REMARKS

Application Number 10/607,634
Amendment dated November 10, 2004
Reply to Office Action of August 13, 2004

Amendments to the Drawings:

FIG. 9

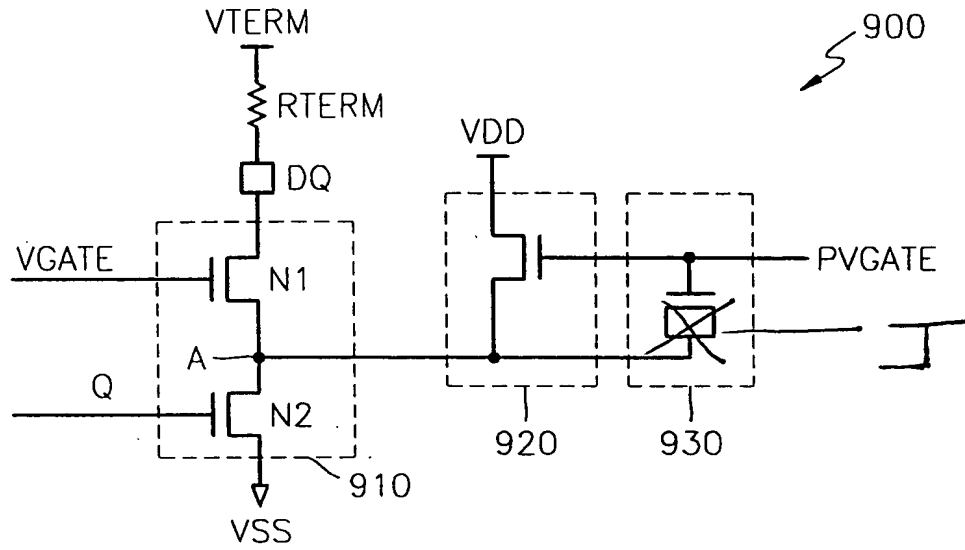
The drawings are objected to as not showing the capacitor set forth in claims 8 and 9. The drawings are further objected to as failing to show a capacitor as described in the specification. Figure 9 is amended herein to clearly illustrate the capacitor in one embodiment of the voltage compensating circuit 930 of the invention. The capacitor is described in the specification as filed at least at page 9, line 32 through page 10, line 2. Accordingly, the amendment to Figure 9 does not introduce new matter into the application.

The attached sheet of drawings includes changes to FIG. 9. The sheet, which includes FIGs. 9 and 10, replaces the original sheet. FIG. 9 is amended to illustrate the capacitor of the invention.
